HISTORIC AND DESIGN REVIEW COMMISSION

November 01, 2023

HDRC CASE NO: 2023-420
ADDRESS: 315 REFUGIO ST
LEGAL DESCRIPTION: NCB 714 BLK 11 LOT S 67 FT OF 12
ZONING: RM-4, H
CITY COUNCIL DIST.: 1
DISTRICT: Lavaca Historic District
APPLICANT: David Hannan Jr/FISHER HECK ARCHITECTS
OWNER: KNIGHT ROBERT WILLIAM & RAMON ALEJANDRO
TYPE OF WORK: Construction of a 2-story addition
APPLICATION RECEIVED: October 13, 2023
60-DAY REVIEW: December 12, 2023
CASE MANAGER: Rachel Rettaliata

The applicant is requesting a Certificate of Appropriateness for approval to construct an approximately 764-square-foot, 2-story rear addition.

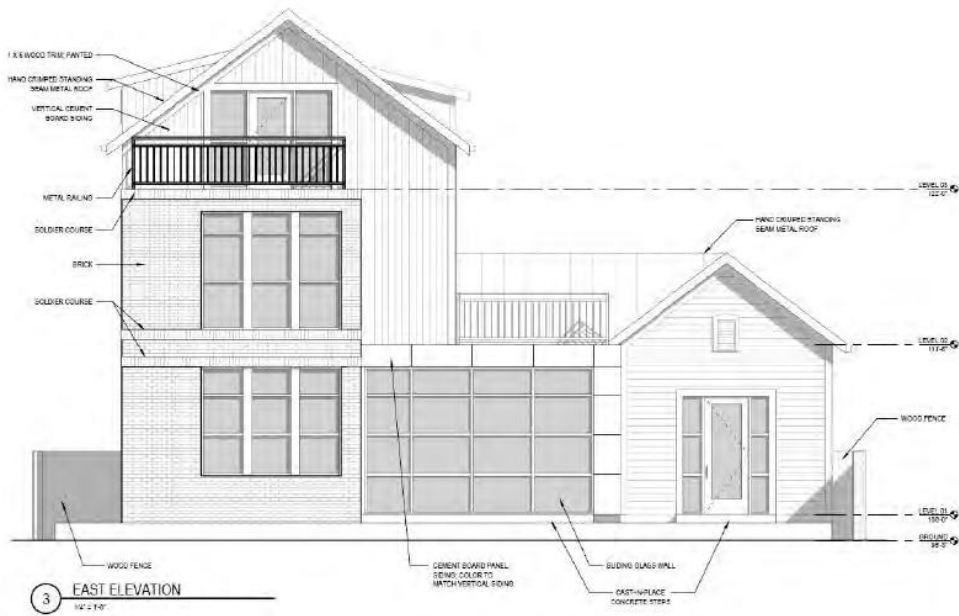
HDRC CONCEPT APPROVAL - DEC 2022

- Explore to see if garage can appear "detached"
- Tweak glazing on addition

HDRC FINAL APPROVAL - OCT 2023

- *Reduce overall massing*
- *Make garage look detached*

INITIAL DRC MEETING - SEPT 2022

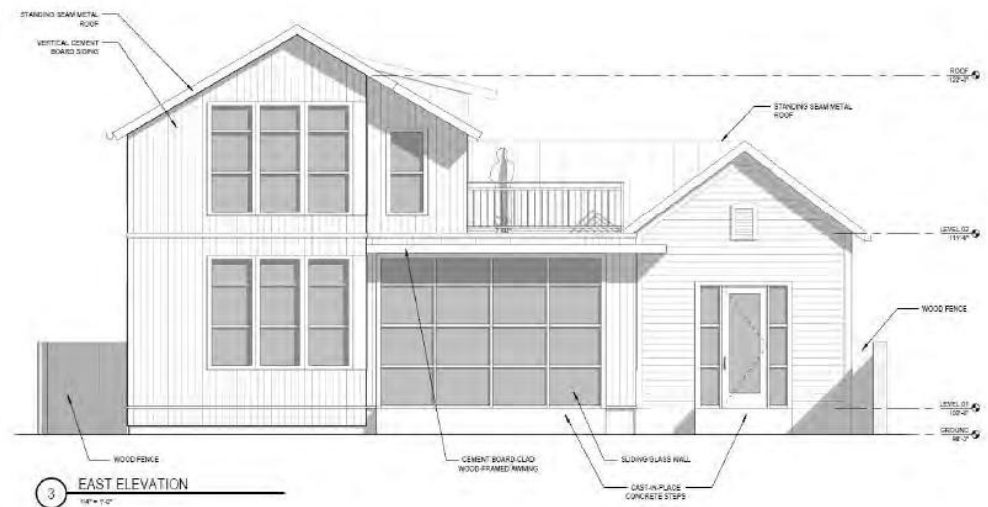
- Reduce overall massing; Too tall!

HDRC FINAL APPROVAL - OCT 2023

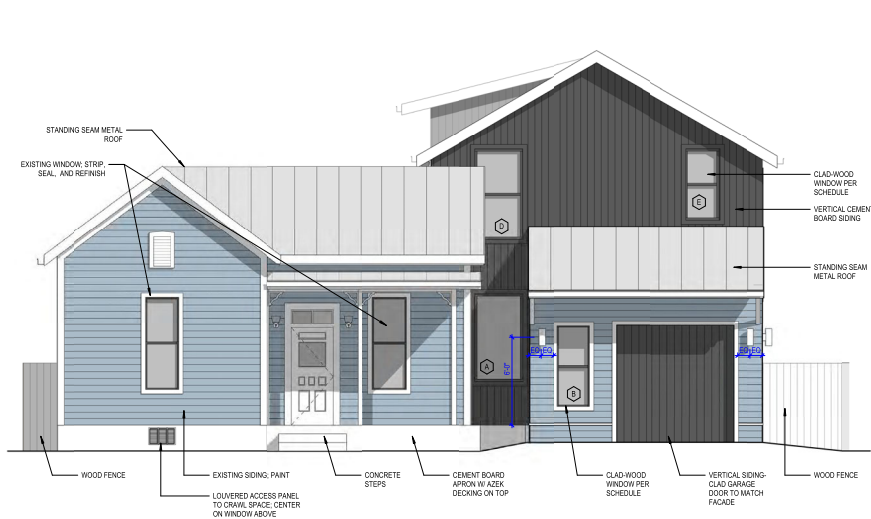
- Remove transom above door @existing wall
- Ensure the door @existing wall is wood framed
